**BC BUILDING SCIENCE & ENGINEERING LTD**

**Strata Plan VAS 2876 (02-0604)****April 16, 2003****FIELD REVIEW****880 West 21st Avenue, Vancouver, B.C.****Page 1 of 3****817/03**

**Existing Roof Framing:**

**PARTIAL ROOF FRAMING PLAN (NORTHWEST CORNER OF BUILDING)**

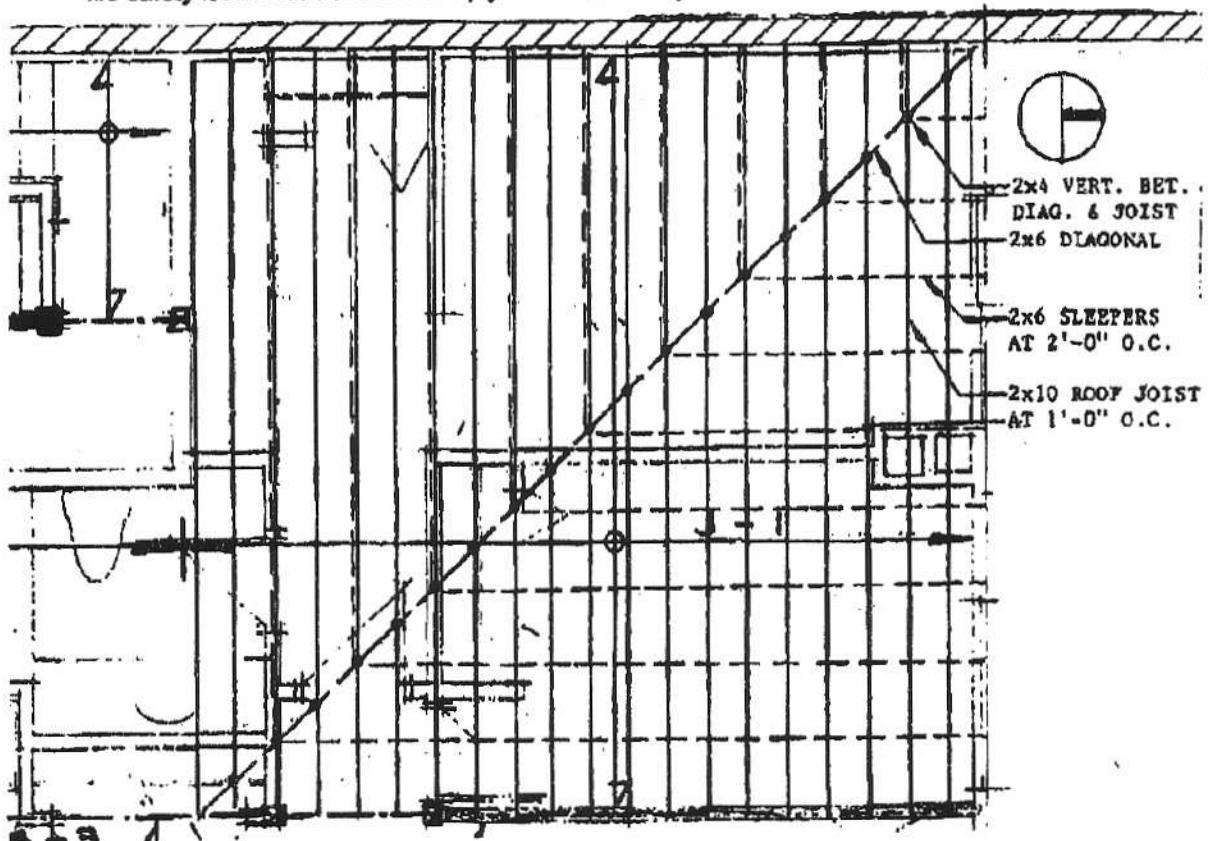
17.1 The contractor has removed a portion of the box joist from select areas at the roof edge to allow us to determine the framing of the roof in order to attach the new roof overhang. At the north edge of the roof (west end - near masonry wall) the 2x8 sleepers have been installed with a 3" space between the underside of the sleepers and the top of the 2x10 roof joists. A 2x8 diagonal sleeper (similar to a hip member of a roof) was installed from the northwest corner of the roof and spanned to the southeast. (See enclosed plan on page 2) On the southwest side of the diagonal, the 2x8 sleepers spanned east-west and on the northeast side of the diagonal, the 2x8 sleepers spanned north-south. Vertical pieces of 2x4 have been nailed to the side of the 2x10 roof joists to support the diagonal sleeper. No interior support of the other sleepers was installed. Therefore, the roof joists are not uniformly loaded by the roof sleepers as originally designed. Under building code snow loads:

- a. the 2x8 roof sleepers will deflect more than allowed by the code when the span exceeds 9'-0" and becomes overstressed at spans greater than 10'-9".
- b. the weight of the snow will only be transferred to the roof joists at the supports for the diagonal sleeper. This creates a concentrated load on the roof joist rather than the uniformly distributed load used in the original design. The roof joists will exceed the code allowable deflection limits and become overstressed under this condition.

2. The sleepers may collapse onto the roof joists which would likely result in membrane failure.
3. The sleepers may deflect, resulting in additional ponding of water and possibly localized fractures of the roof membrane.
4. The roof is not constructed to meet the current building code or the building code required at the time of construction. It is difficult to predict when or if this condition could result in a life safety issue. We do note that wood framing has additional capacity above the code limits due to variations in lumber strengths.

We recommend that additional plates be installed, perpendicular to the roof joists at 2'-0" o.c. (or under each sleeper) to fill in the space between the sleepers and roof joists. This work is necessary for two reasons:

- a. This will uniformly distribute the snow load along the entire span of the 2x10 roof joists as per the original structural design.
- b. The plates will provide lateral support for the top edge of the roof joists.
